Changes to the approved volume of tailings stored (pg ES-2)

Newmont
CADVA
CADIA VALLEY OPERATIONS
Typical Cross Section through the
Northern Tailings Storage Facility
Main Embankment
Figure 2-1b

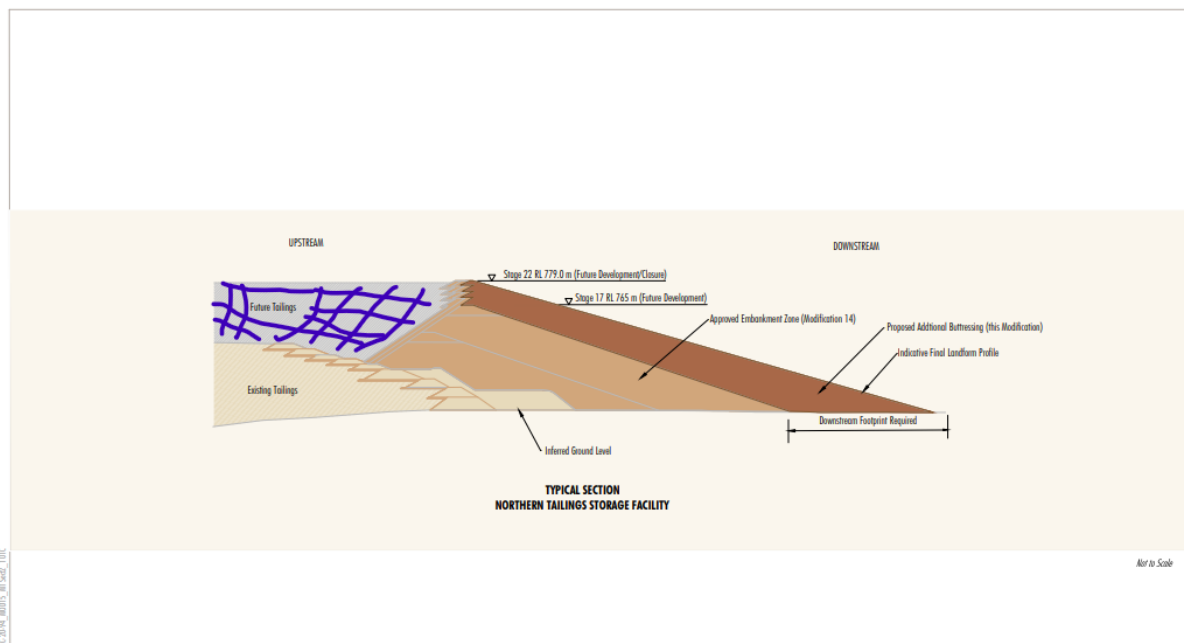
Changing the tailings dam construction from upstream to centreline or downstream will result in a significant increase in storage capacity (blue cross hatched area). The dam wall will effectively be built in a line upwards rather than building over the current tailings dam. The Advisian model (Appendix D – Groundwater Impact Assessment) for the NTSF and STSF revises the cell matrix used to model the tailings dam footprints and identifies an increase in the tailings dam footprint area by 200 modelled cells, approximately 20% (Figure 5-2).

- Descriptions that buttressing the outer slopes of both the NTSF and STSF and moving to a centreline or downstream lift has no change in the volume of tailings material stored or the footprint of the stored tailings is false. The assertion that all tailings deposition would remain within existing MLs is totally misleading. The notice of exhibition for the Mod is deliberately intended to mislead and downplay the significance of Mod 15.
